CONTINUING ELIGIBILITY INSPECTION (CEI) REPORT

FOR FLOOD CONTROL PROJECTS

1. Project Name: Alenaio Flood Control Project

2. Date of Inspection: November 12, 2002

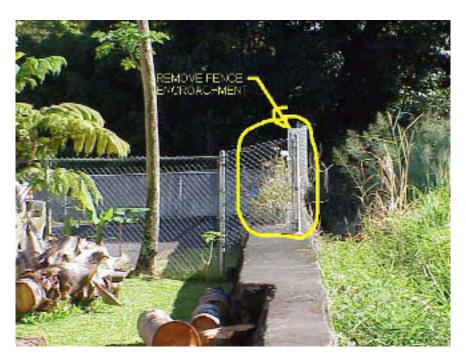
a. Sta. 3+65, Floodwall "A", overview. (Sta. 3+65 CRM wall begins upstream - Sta. 0+00 wall ends downstream).
